Notice of Allowability

10/726,964

JURGILEWICZ ET AL.

FIG. 2

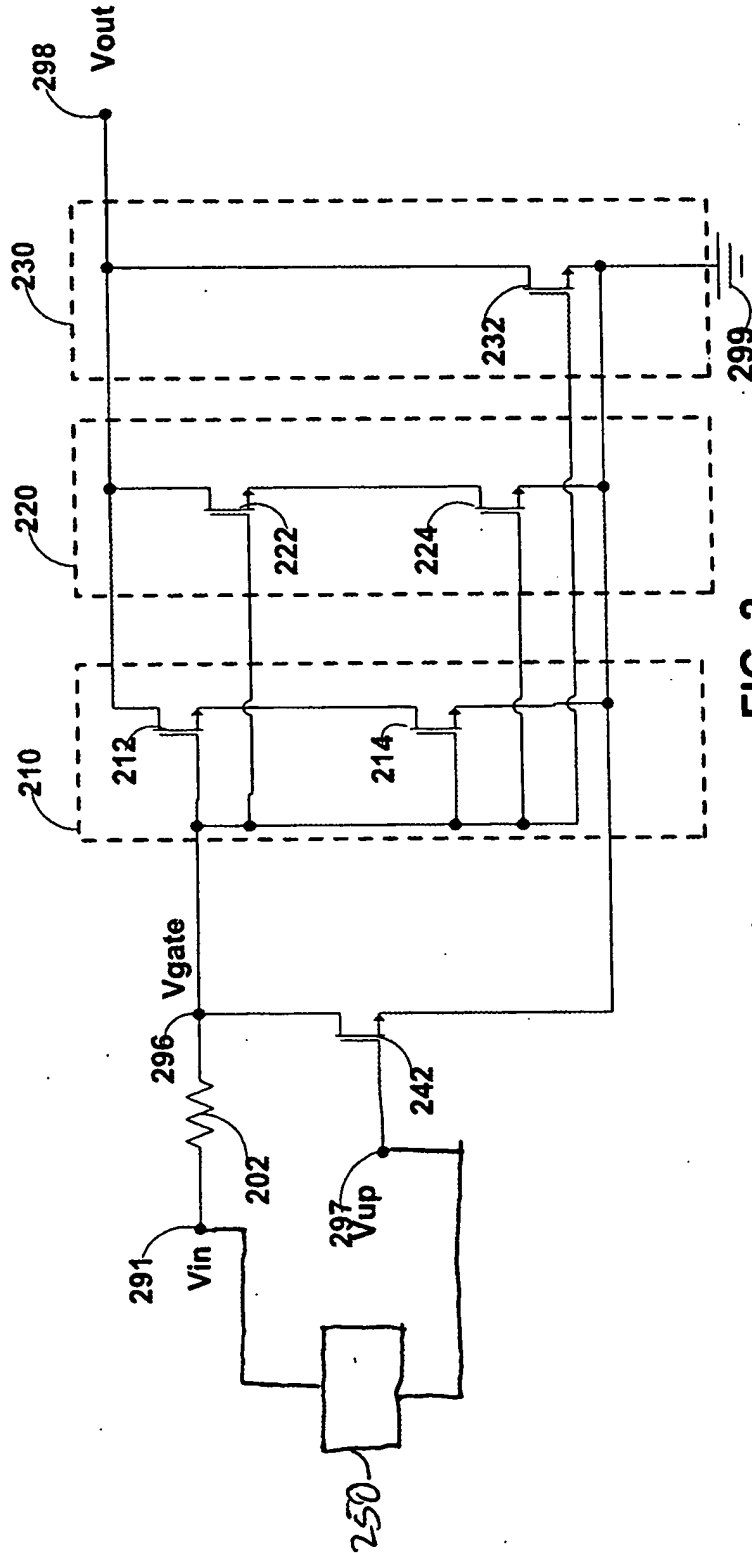
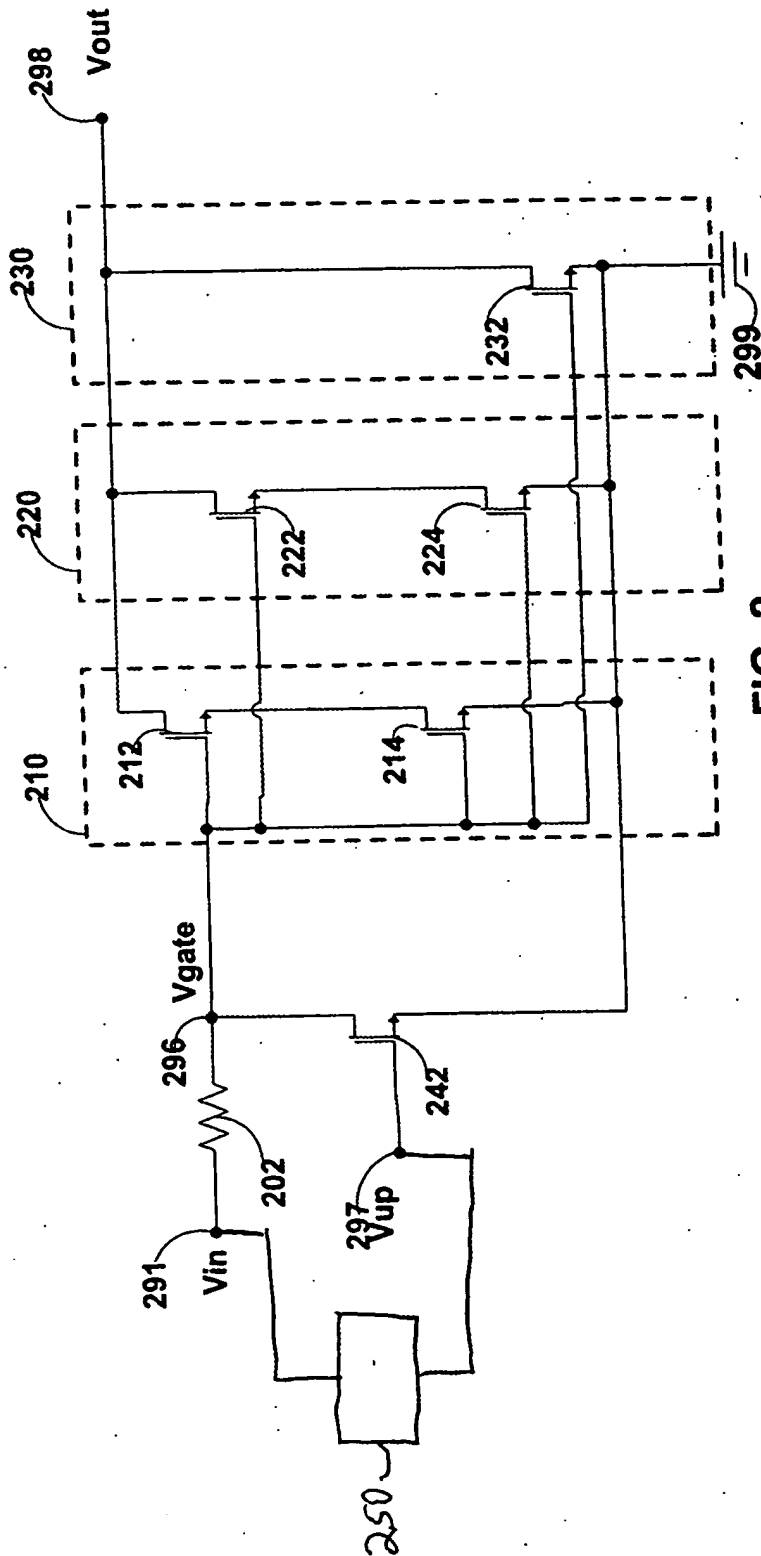
1. The following is an examiner's statement of reasons for allowance: the amendment filed 4/5/2005 has overcome the prior art of record and the technical deficiencies. The prior art of record fails to teach or fairly suggest a control node (V_{up} of figure 2), wherein said output node is pulled up to a logic high voltage when a logic high voltage is applied to said control node as called for in claim 1, a third sub circuit comprising a fourth and fifth NMOS transistors coupled to the input node and the ground terminal as called for in claim 18, a pull down transistor coupled to said first sub circuit, wherein said output node is pulled up when a voltage high is applied to the gate terminal of said pull down transistor (transistor 242 of figure 2), an intermediate node, a resistor, a first PMOS switch, wherein the source terminal of said first PMOS switch is coupled to said input node, the gate terminal of said first PMOS switch is
